Project: HVAC replacement project, EXHIBIT A

BID ADDENDUM 1

PARK VIEW HVAC IMPROVEMENTS
VICTOR ELEMENTARY SCHOOL DISTRICT
VICTORVILLE, CA

EXHIBIT A - ADDENDUM – 01

SHEET NUMBER:
A5-1.6

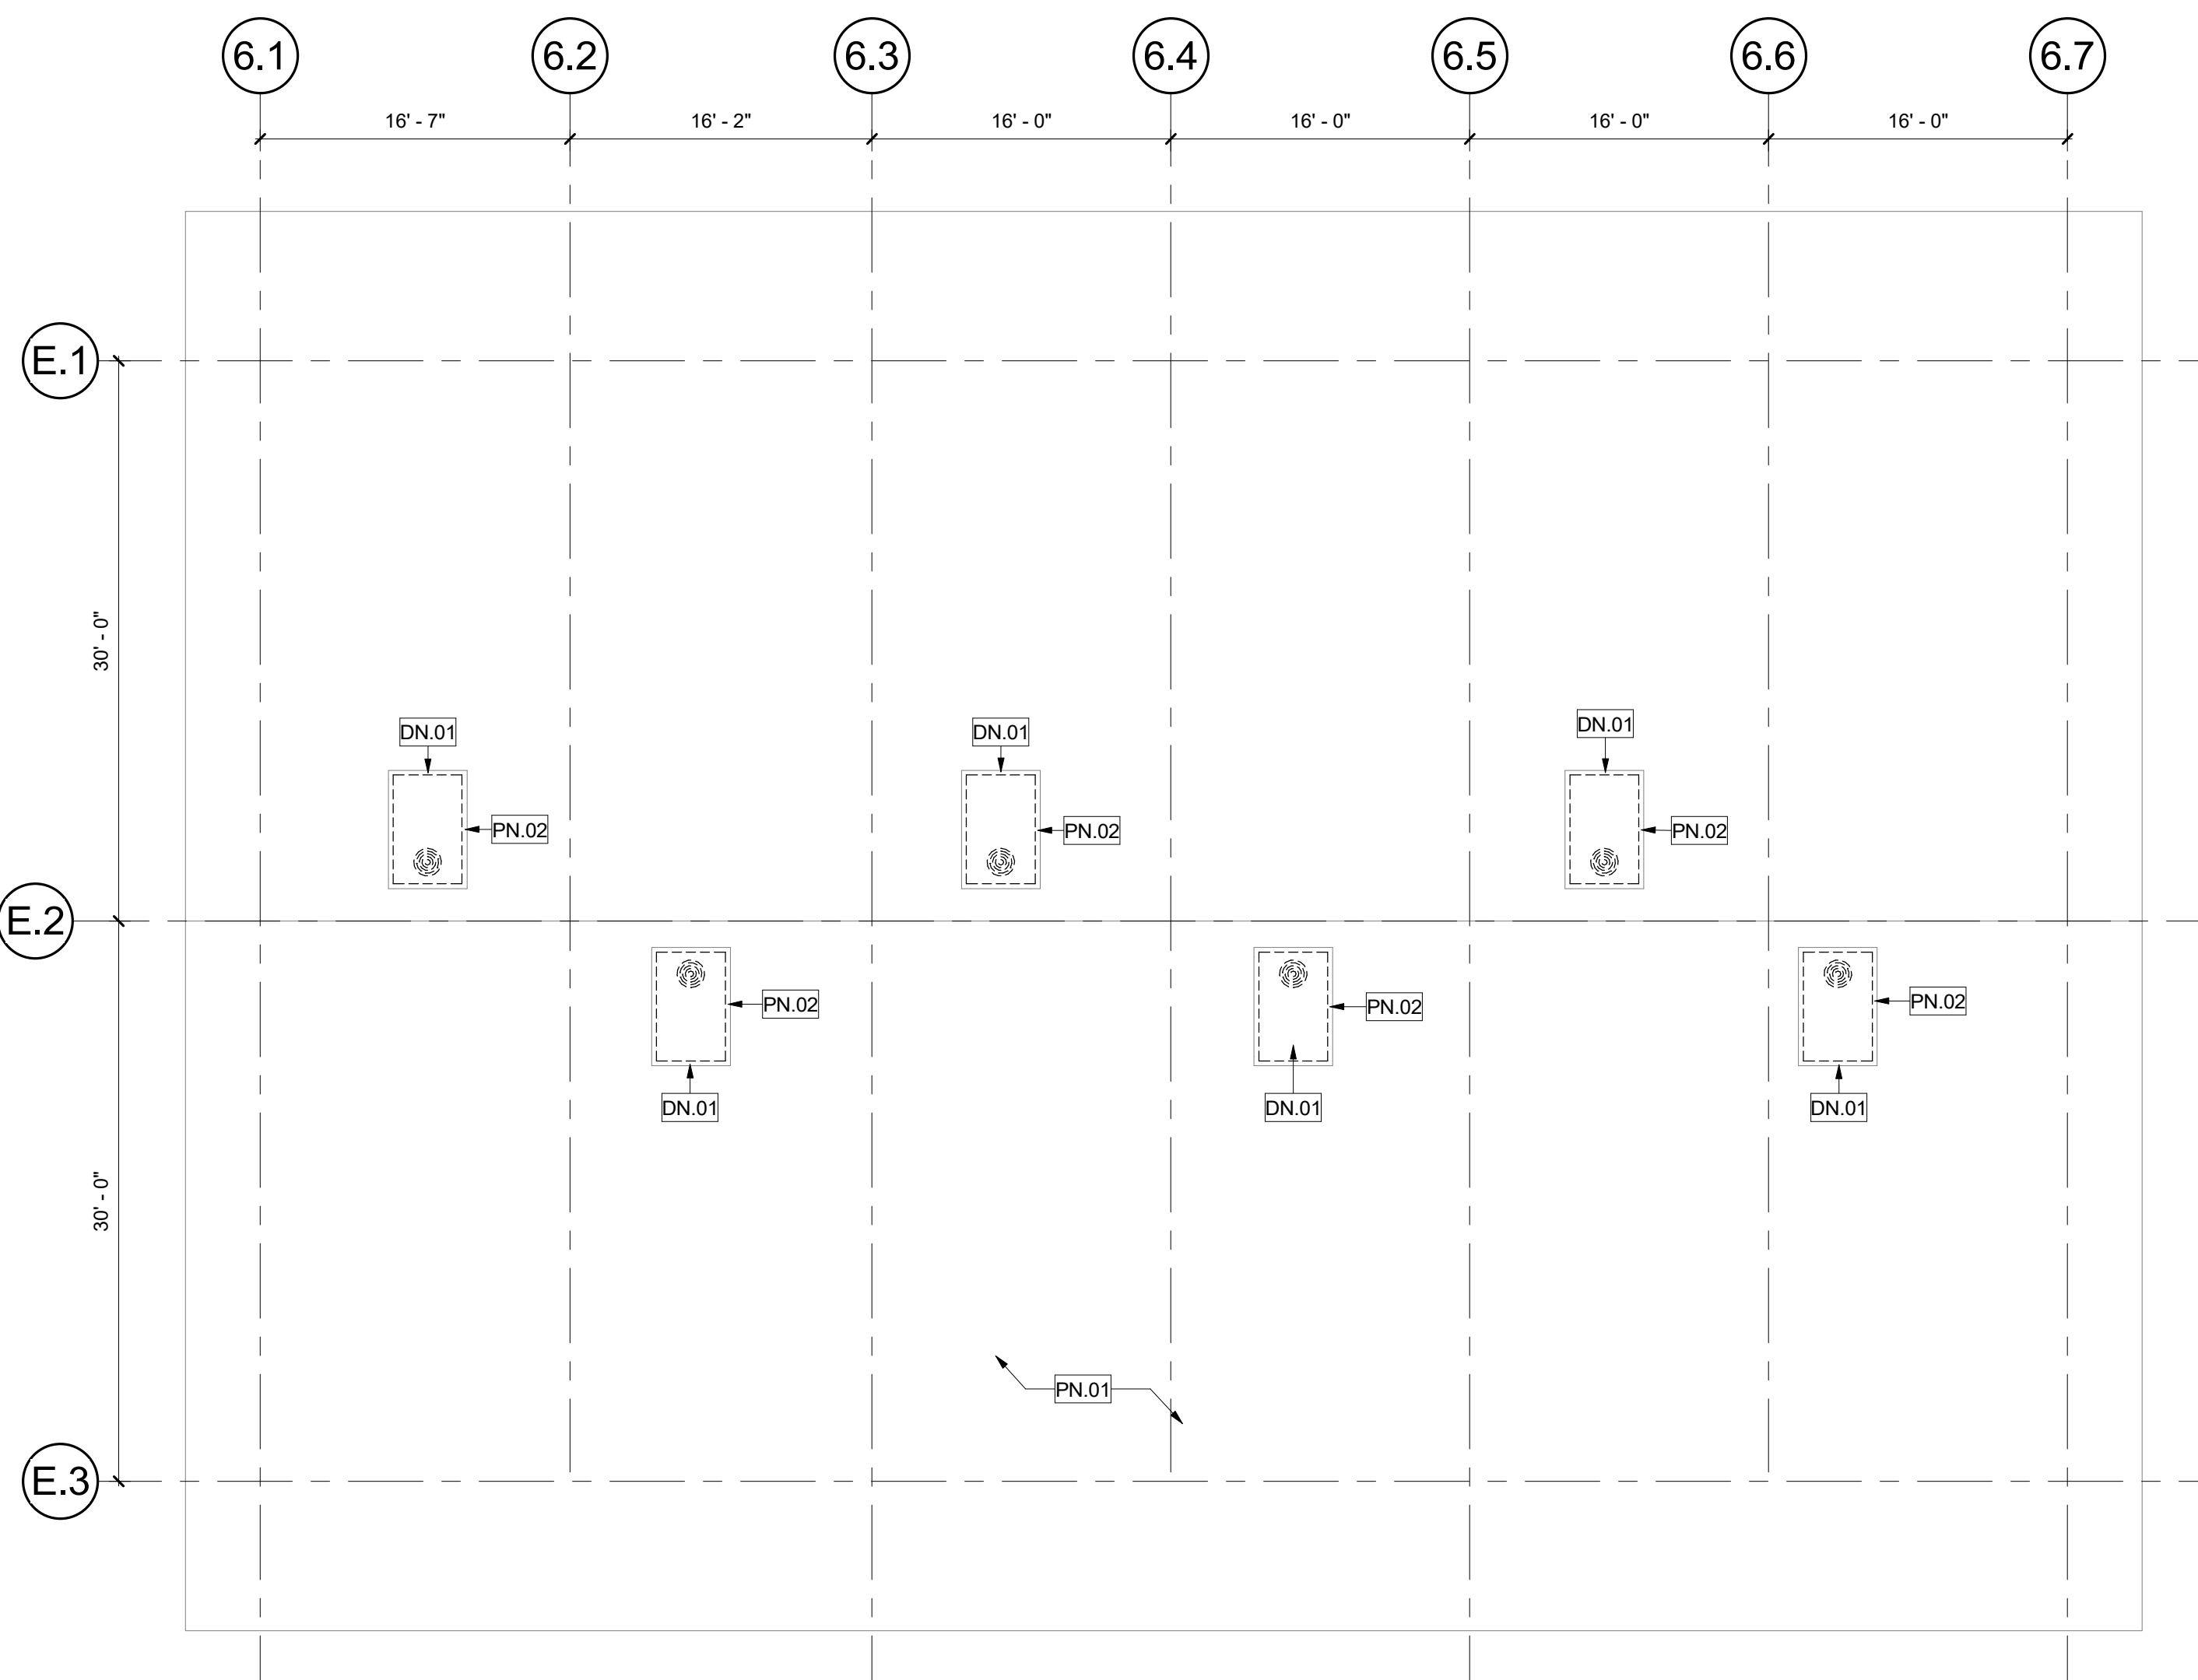
A5-1.6 ROOF PLANS - BUILDING E – CLASSROOMS

- Legibility error

- ITEM NO. 1 PROJECT MANUAL, SPECIFICATION SECTION- 001116 NOTICE INVITING BIDS
- A. The bid deadline remains 02:00:00 o'clock PM. on the **4th day of March, 2024**. The location for receipt of Bids remains the District Office for Victor Elementary School District, located at 12219 2nd Ave., Victorville, CA 92395.
- ITEM NO. 2 DSA APPROVED PLANS – PARK VIEW HVAC IMPROVEMENTS – SHEET A5-1.6
- A. Updated sheet with missing information called out.
